**PLANNED UNIT DEVELOPMENT
& SUBDIVISION STAFF REPORT****Date: September 20, 2018****DEVELOPMENT NAME**

Austal / AT & T Subdivision

CONTEMPLATED USE

SITE PLAN

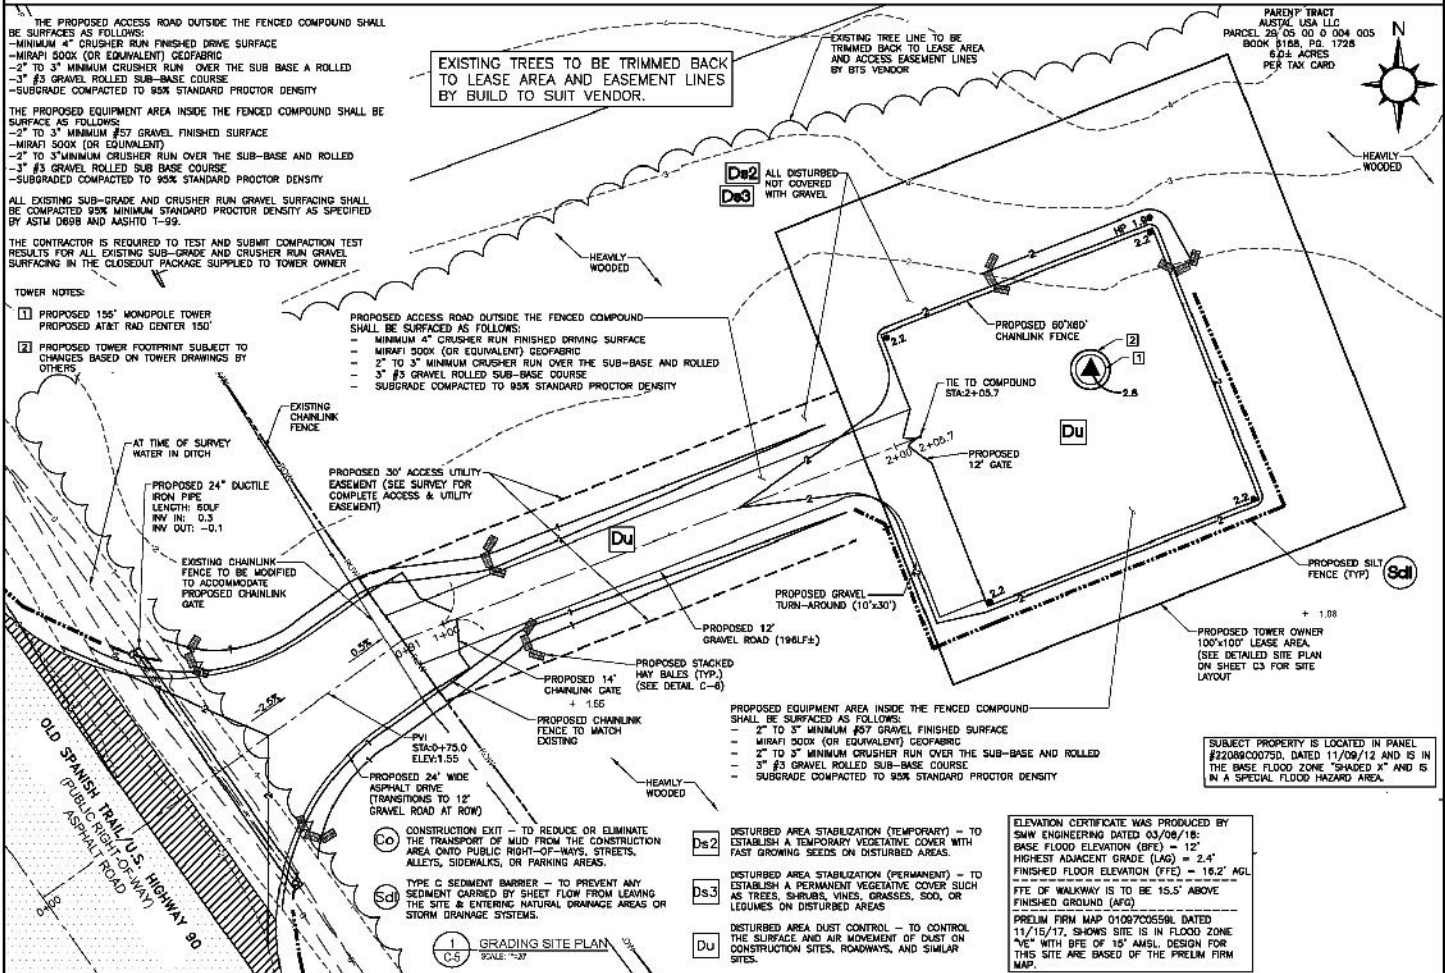
The site plan indicates the proposed 100' x 100' tower lease area and 30' wide access easement from Cochrane Causeway, across a portion of the parent parcel. The site plan should be revised to indicate the lease area as Lot 2 and the remainder of the parent parcel as Lot 1, with each lot labeled with its size in both square feet and acres, or with the furnishing of a table on the site plan providing the same information. The site plan should also be revised to label the current right-of-way width of Cochrane Causeway along the site frontage.

As stated above, the 50' spoil disposal and pipe line right-of-way and easement along the front of the site is indicated on the preliminary plat for the Subdivision; however, it is not illustrated on the preliminary PUD site plan. The PUD site plan should be revised to show this right-of-way/easement with the easement line also identified as the 50' minimum building setback line. A note should be placed on the site plan stating that no structure may be placed or constructed within the easement.

The site plan indicates a gravel drive within the right-of-way extending into the access and utility easement to the tower lease area. This is allowed in I-2 districts; however, gravel paving is not

allowed within the public right-of-way. As per the Traffic Engineering comments, gravel may not extend into the right-of-way of US Highway 90. Therefore, the site plan should be revised to provide a paved surface within the public right-of-way, to be coordinated with Traffic Engineering and ALDOT. Chainlink gates are indicated within 8' from the right-of-way line. As this does not allow a vehicle to queue completely out of the right-of-way, the site plan should be revised to provide at least a 20' queuing depth from the right-of-way.

Two evergreen trees are indicated within the right-of-way; however, any required trees must be planted on-site. As the access easement is 30' wide, only one frontage tree is required, but must be placed within the 25' front setback. As the site has a 50' recorded easement along the front, one overstory tree should be planted within the access easement just beyond the 50' recorded easement. This tree should be at least 3" in diameter at breast height, when planted.

The site plan indicates a proposed 60' x 60' chainlink fence around the tower compound. This should be revised to specify that the fence be an 8' high wooden privacy fence. No public sidewalk is indicated within the public right-of-way. As Lot 2 would be developed for the proposed tower, a public sidewalk along the frontage of the access easement would be required. Therefore, the site plan should be revised to illustrate a compliant City-standard sidewalk along the street frontage, or a Sidewalk Waiver obtained.

- 1) revision of the site plan to indicate the lease area as Lot 2, and the remainder of the parent parcel as Lot 1, with each lot labeled with its size in both square feet and acres, or the furnishing of a table on the site plan providing the same information;

- 2) revision of the site plan to label the current right-of-way width of Cochrane Causeway along the site frontage;
- 3) revision of the site plan to illustrate the 50' spoil disposal and pipe line right-of-way and easement line, and to also label it as the 50' minimum building setback line;

- 4) placement of a note on the site plan stating that no structure may be constructed or placed within the 50' spoil disposal and pipe line right-of-way and easement;

- 5) revision of the site plan to provide a paved surface within the public right-of-way to the access easement, to be coordinated with Traffic Engineering and ALDOT;

- 6) revision of the site plan to provide a minimum 20' of vehicle queuing space between the right-of-way and gates along the access drive;
- 7) revision of the site plan to provide one overstory tree within the access easement just beyond the 50' recorded easement to be at least 3" in diameter at breast height when planted;

- 8) revision of the site plan to specify that the 60' x 60' fence around the tower compound be an 8' high wooden privacy fence;
- 9) revision of the site plan to provide a compliant City-standard sidewalk along the street frontage, or the obtaining of a Sidewalk Waiver;
